TO:	CHAIR AND MEMBERS LONDON ADVISORY COMMITTEE ON HERITAGE MEETING ON FEBRUARY 11, 2015
FROM:	JOHN M. FLEMING MANAGING DIRECTOR, PLANNING AND CITY PLANNER
SUBJECT:	APPLICATION BY: 1873649 ONTARIO LTD. (J. FYFE-MILLAR) 387 CLARENCE STREET

That, on the recommendation of the Managing Director, Planning and City Planner, with the advice of the Heritage Planner, the Heritage Alteration Permit Application of J. Fyfe-Millar, requesting permission for window alterations to the designated heritage property located at 387 Clarence Street **BE APPROVED** with the condition that the final window models chosen be similar to what is described herein to the satisfaction of the Heritage Planner; it being noted that the Heritage Planner has reviewed the proposed window replacement and has advised that the impact of such alteration on the heritage features of the property identified in the reasons for designation is acceptable.

Appendix 2- Photos -387 Clarence Street -Exterior

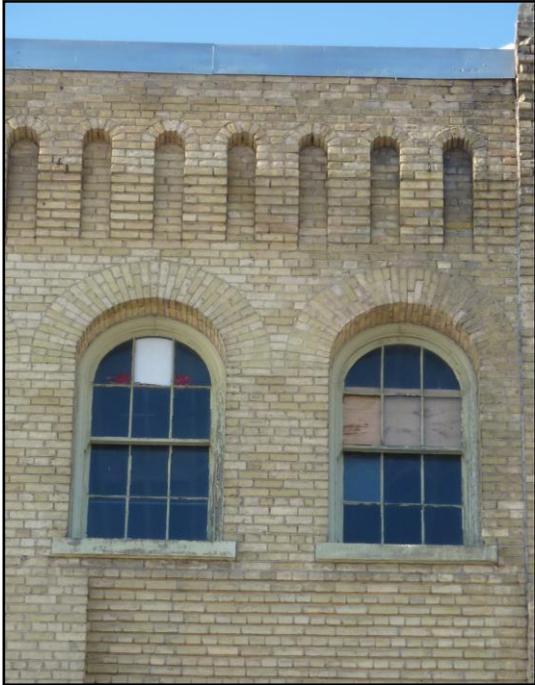
Regarding the proposed window replacement for the front façade windows, ideally, the preference would be to maintain original windows if possible. Restoration rather than replacement would be the preferred option.

D. Menard:
 architecture.” The return of windows on the north façade will restore a more original appearance to the building as later changes to the building had removed many of these windows as can be seen in the brickwork.

As the final window model has not yet been determined with respect to the manufacturer/supplier, it is recommended that the alteration application be approved subject to the approval of the heritage planner(s) of the replacement window model when known.

Appendix 2 Continued- Photos

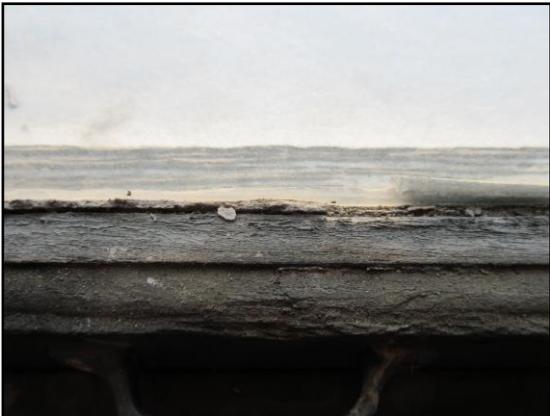
With respect to the proposed window replacement program, the application retains existing window openings and sizes. While a final window manufacturer has not been determined, the applicant has submitted a window featuring a segmental arch style, similar to what is present on the second and third floors, and has indicated that the muntin pattern will replicate the existing pattern. The proposed new windows will be wood (pine) clad with black aluminium on their exterior. Rounded arch windows will replace existing rounded arch windows on the fourth floor.

In relation to the Guidelines, the proposed window replacements will respect the originals in type, proportion, vertical orientation and size of elements. The proposed replacements will be wood windows clad with aluminium. The existing mullion detail will be replicated. While the aluminium cladding is an alteration, the other elements respect “the spirit of the original
